Comments on a Substantive Application under section 53 of the Fast-track Approvals Act 2024: Parks

Fast-track project name	Mt Welcome, Pukerua Bay, Porirua
Fast-track application no.	FTAA-2603-1181
PCC reference	RCO26120

Technical area	Parks
Date	30 July 2026
Author	Matt Hoffman, Manager Parks Planning Niamh Brady, Resource Planner Parks
Statement of expertise	Matt Hoffman I am employed as a Parks Planning Manager in the Infrastructure Group, Parks Team of the Porirua City Council. I hold the degree of Bachelor of Applied Science in Environmental Manager (Honours) and Master of Science in Geography from the University of Otago. I am an Associate Member of the New Zealand Planning Institute. I have 15 years work experience as a Planner in New Zealand. Niamh Brady I am employed as a Resource Planner Parks in the Infrastructure Group, Parks Team of the Porirua City Council. I hold the degree of Bachelor of Arts in Human Geography from University of Otago and a Master of Urban Planning and Design from University of Auckland. I am an Intermediate Member of the New Zealand Planning Institute. I have 2.5 years work experience as a Planner in New Zealand.

Figure 1: Composite of proposed contours
Source: Appendix 30-06 Proposed Contours Overall

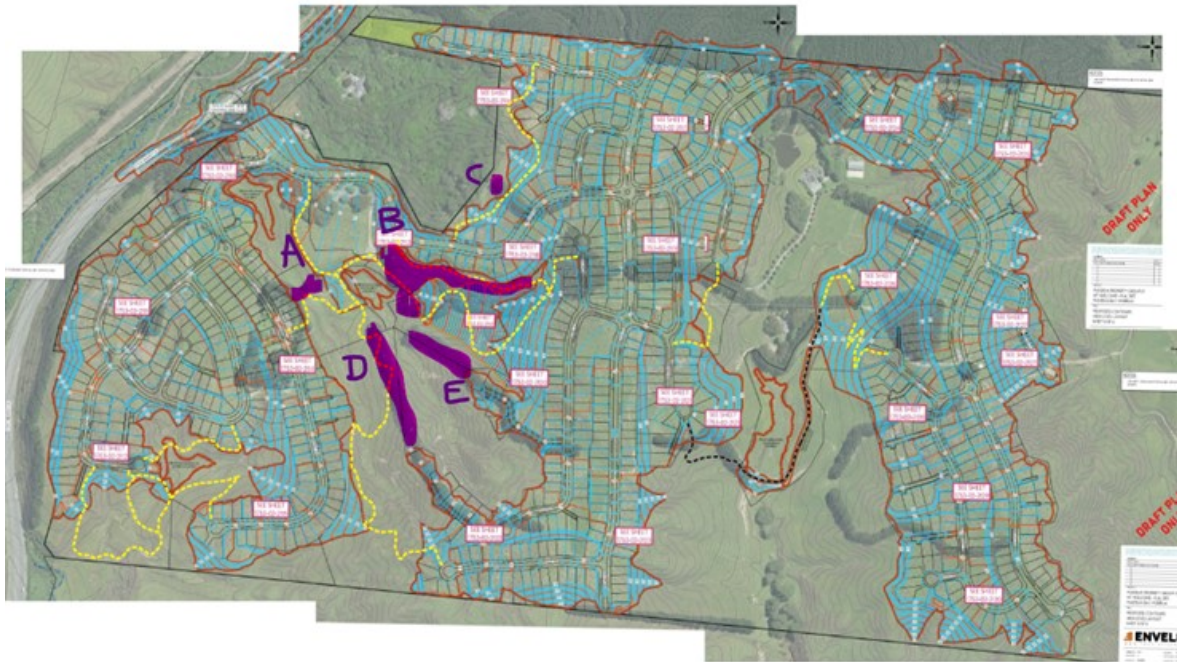
We have concerns regarding Area B (identified in Figure 1 below), in relation to the removal of the woodlot on the east side. The walking track that is also proposed will create a narrow sliver of trees. Any trees newly exposed will be prone to failure. A condition of consent requiring details of the works planned around the woodlots, and what is proposed to remain, is necessary in our view. If the slivers of pine are proposed to stay they will likely fail in a storm event as they will be newly exposed to wind. We recommend a pine management plan as a condition.

Figure 5: Southern Lucas Block Park

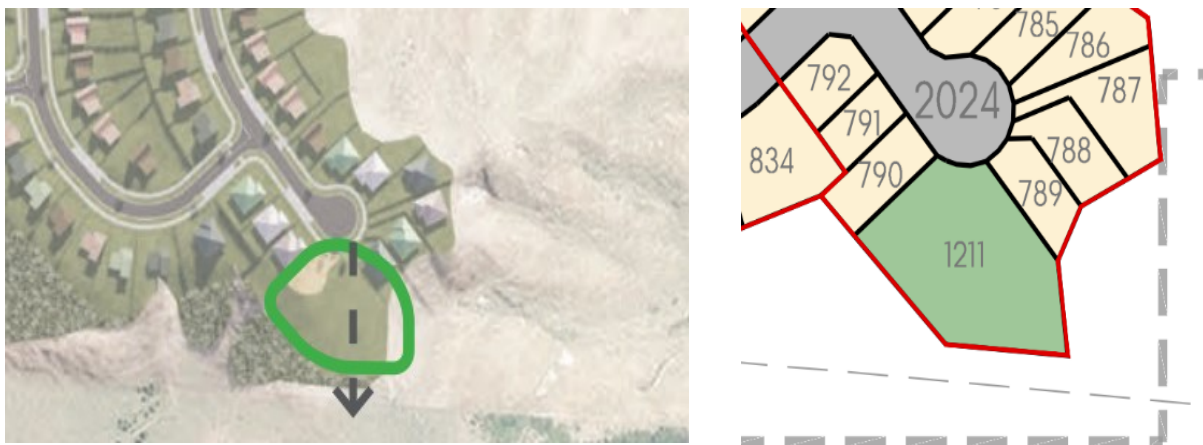
The MLUDS identifies a future connection going through a proposed reserve (Figure 5). This should be clarified as to whether it is a proposed active transport or roading connection. If it is a proposed future road connection, it will conflict with the proposed reserve and this will need to be resolved. The total neighbourhood reserve area proposed in the application is appropriate, so potential loss of this reserve would need to be made up elsewhere to achieve good recreational and open space outcomes.

Figure 8: Key Guidance Documents of the MLUDS

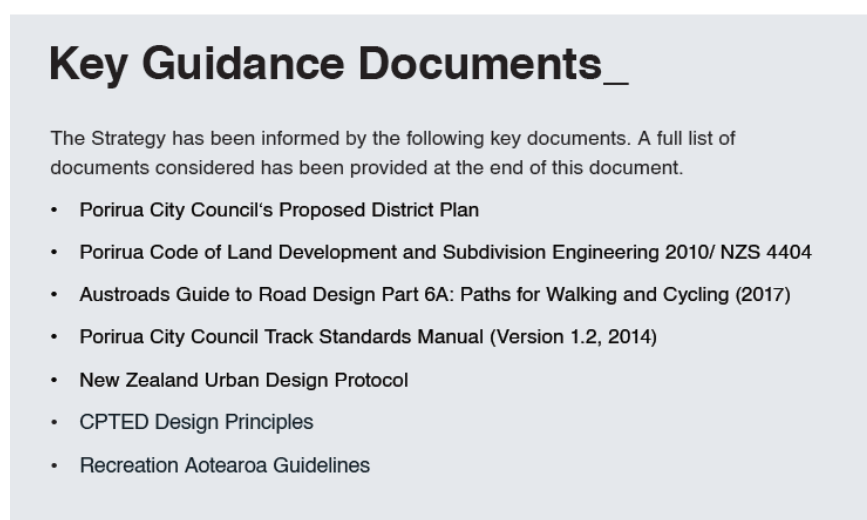
The plans show some potential off-road track connections which could potentially be beneficial; however, we have significant concerns with their design and layout. The plans identify that the following standards have been referenced, as reproduced in Figure 8.

Figure 10: Proposed tracks and contours

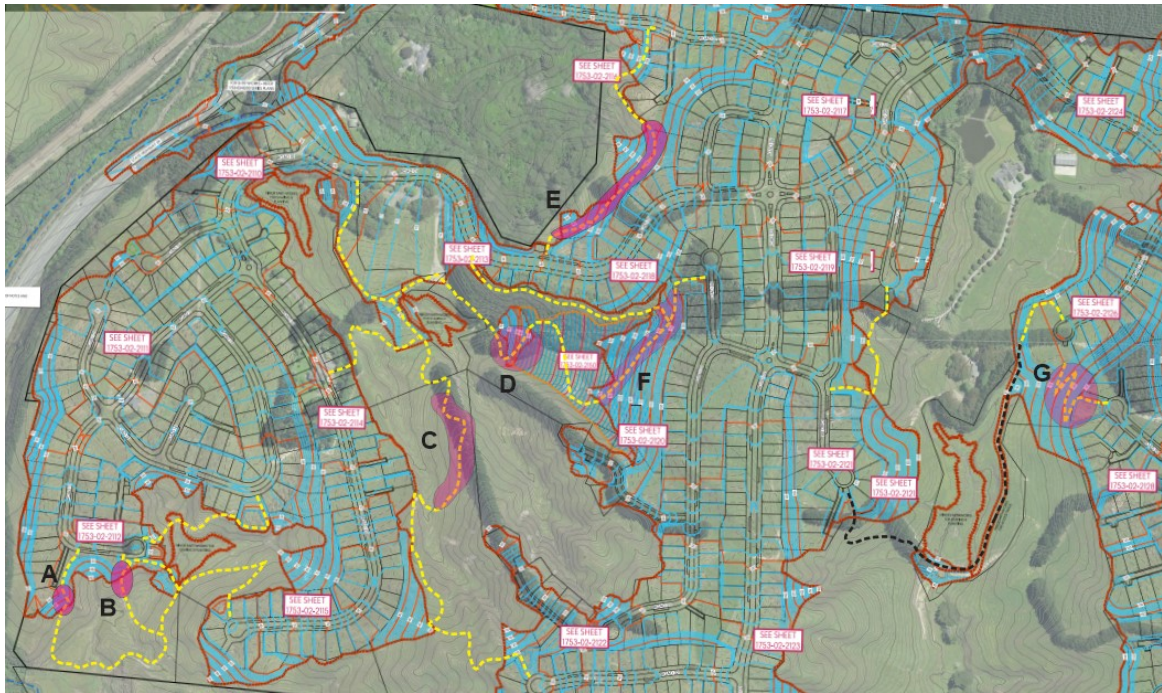
The plan in Figure 10 below shows areas where the tracks cross land where the contour lines are close together. The land is already vulnerable to slips as identified in the geotechnical investigation provided with the application. The erosional risk created by additional stormwater

pressure from urbanization, and channelization caused by cutting new roads and tracks that direct and focus water flows, should be clarified.

How the fill slopes will be treated that have tracks identified on them, and will they form the cut, is considered to be missing information. It is not an ideal outcome to have tracks running through fill slopes. The engineering plans should show the formation and the gradient of the tracks that meet Council standards. This includes identifying how tracks along fill batters will be designed to prevent future geotechnical issues. We recommend that geotechnical solutions use low-maintenance methods.

In many places, such as shown with area E above, new fill faces are proposed that appear to be gradients of around 1-in-2. The plans also show a track proposed to cross the new fill face, but no bench has been provided within the fill face to accommodate the new pathway. This is a requirement for sustainable tracks. Plans that consider both tracks design and fill batters to provide suitable and sustainable outcomes should be provided.

Figure 11: Example of areas of issues with proposed track locations

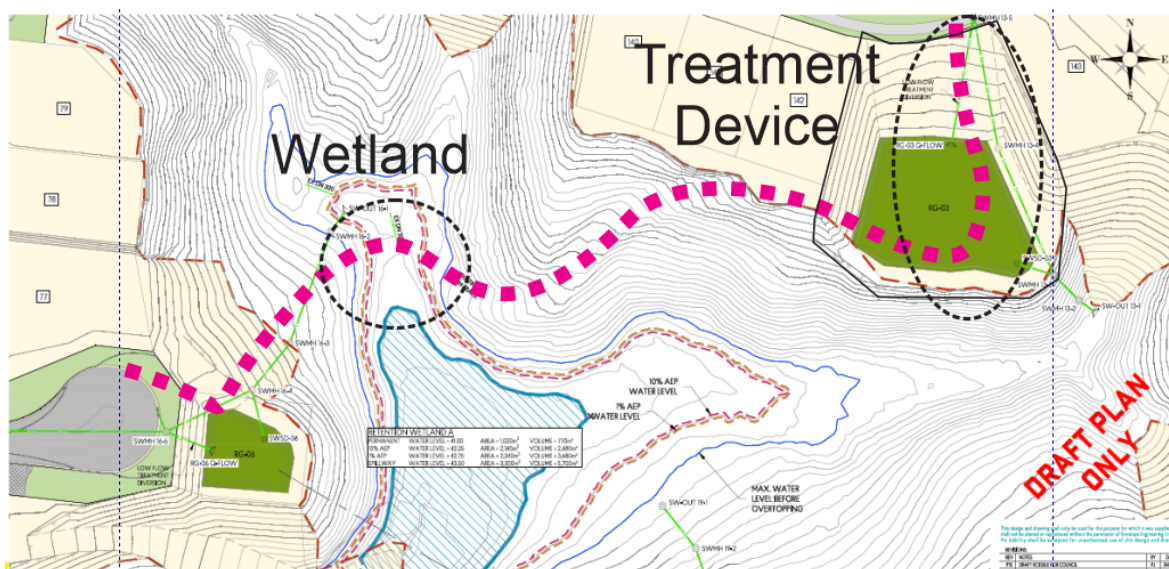
When the track alignment is overlaid onto the proposed earthworks contours for the area, it raises significant concerns. There appears to have been limited consideration for the tracks reflected in the earthworks proposal.

The example in Figure 11 below shown that at the west end it drops down a steep earth worked face then goes through a retention wetland. From the wetland it then passes through a stormwater water treatment basin which is surrounded on all sides by steep batters. It is unclear how it can be delivered within the current design. Should the scheme plan progress as shown, the easement corridor for this path would be locked in with no ability to consider alternatives to remedy the significant constraints currently for building the pathway.

Figure 12: Example of proposed track on fill area

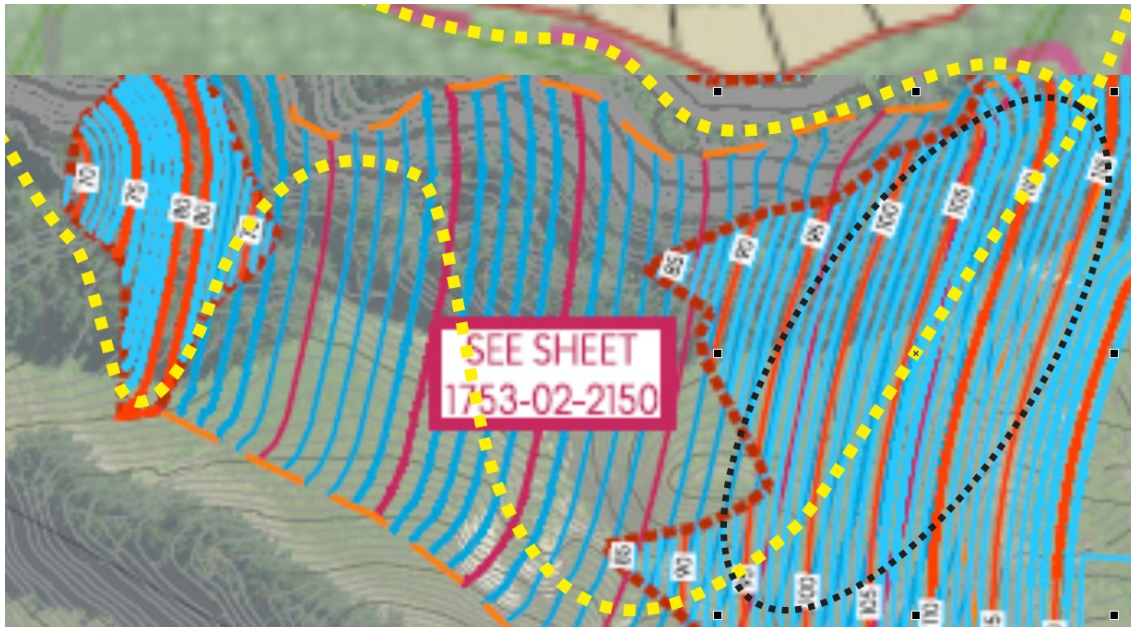
In the case of the pathway shown in Figure 12, it is shown crossing over three fill faces, two of which are very steep, where the earthworks have not been designed to accommodate the pathway.
